September 26, 2016

Docket ID No. EPA-HQ-OAR-0827

Docket ID No. NHTSA-2016-0068

Alliance of Automobile Manufacturers Comments on Draft Technical Assessment Report: Midterm Evaluation of Light-Duty Greenhouse Gas Emission Standards and Corporate Average Fuel Economy Standards for Model Years 2022-2025 (EPA-420-D-16-900, July 2016)

Figure B-2: ATK2 Torque Curve Discrepancy between SAE and ALPHA^{98,99}

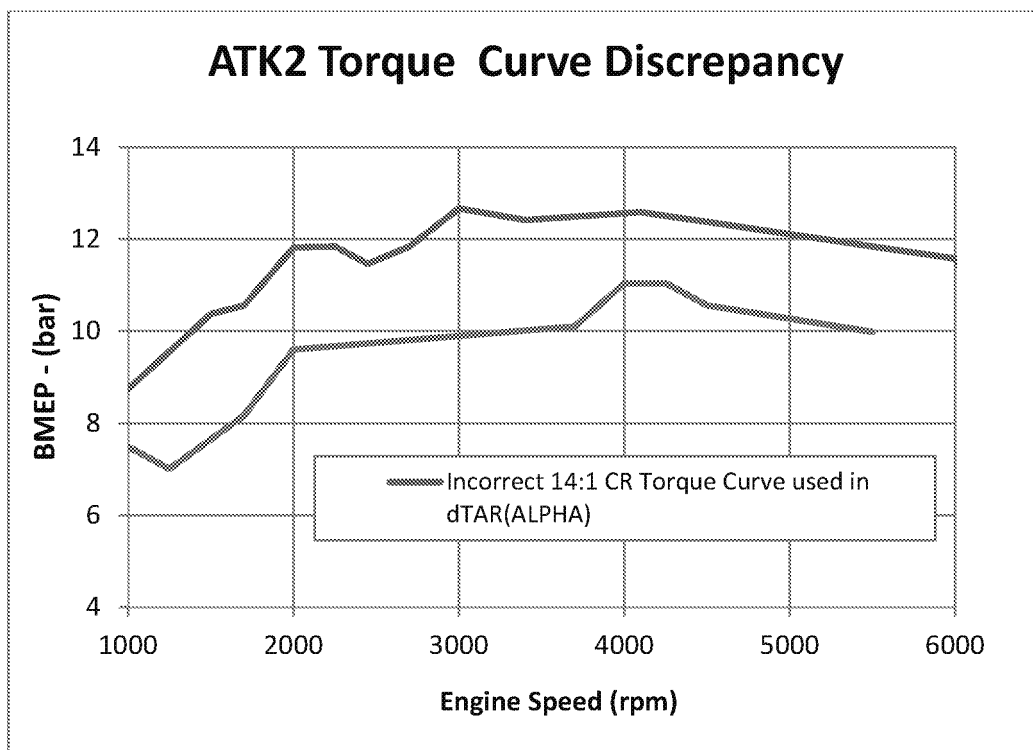
Additionally, it appears that there was a serious clerical error in translating the GT-POWER full load torque data to ALPHA which was then carried into the LPM's calibration. We note that in the SAE paper 2016-01-0565⁹⁶ the GT-POWER model correctly limited the full load torque of the engine due to knock onset. However, it is not clear that this significant reduction in torque was translated to the Advanced Atkinson Tech Package used in ALPHA simulation work which was subsequently used to calibrate the LPM model. This error incorrectly leads to exercising downsizing options because the performance metrics could theoretically be met with the torque that should have been limited as shown in SAE paper 2016-01-0565.⁹⁷ The net result is a large overestimation of the benefit with the Advanced Atkinson Tech Package. The modeled performance would be further degraded if correct CEGR assumptions were used as discussed below. Figure B-2 compares the two torque curves, baseline Atkinson, and the Advanced Atkinson Tech Package.

Figure B-3: MY 2025 Advanced Atkinson Tech Package Penetrations in the EPA Control Case Central Analysis with ICMs¹⁰²

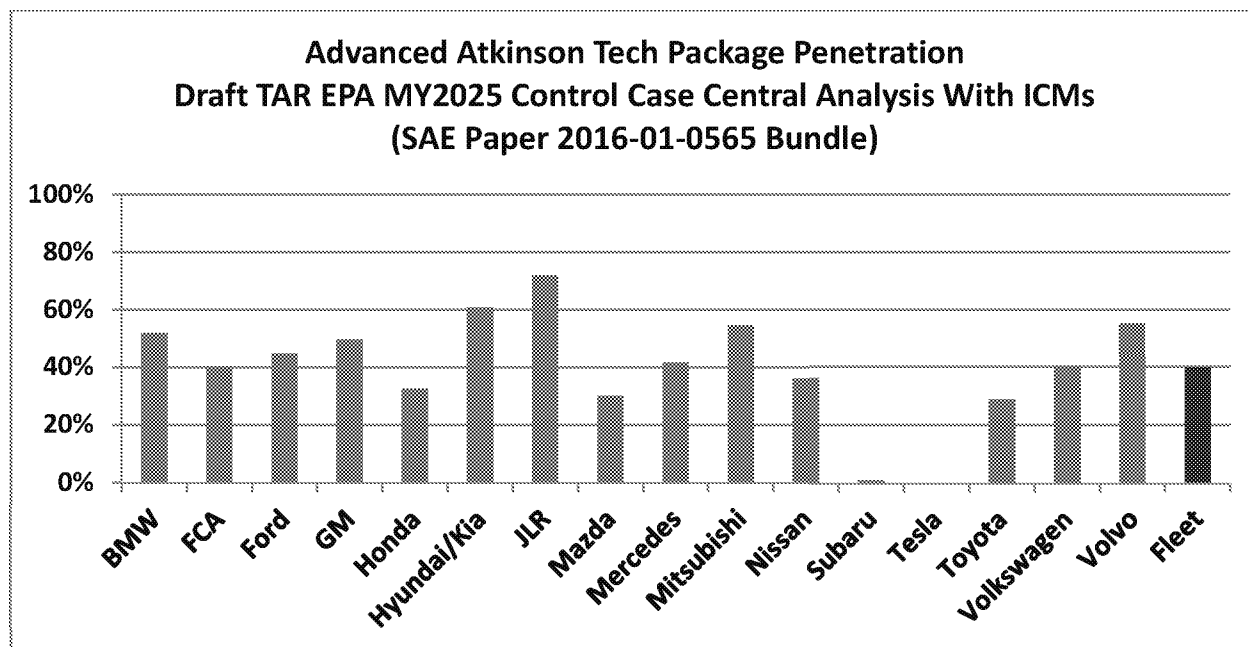
For the Draft TAR, EPA modeled that almost every automaker (except Tesla which only produces battery electric vehicles) will adopt the Advanced Atkinson Tech Package by MY2025 (Figure B-3), and that a number of manufacturers will exceed 50% penetration of this technology

package. Even though Atkinson cycle engines in non-hybrid applications have begun to appear in the marketplace, the Alliance does not believe that this high technology penetration is likely or feasible. Even more questionable is the estimate that 40% of the fleet will have the Advanced Atkinson Tech Package, which has yet to be realized in any production engine.
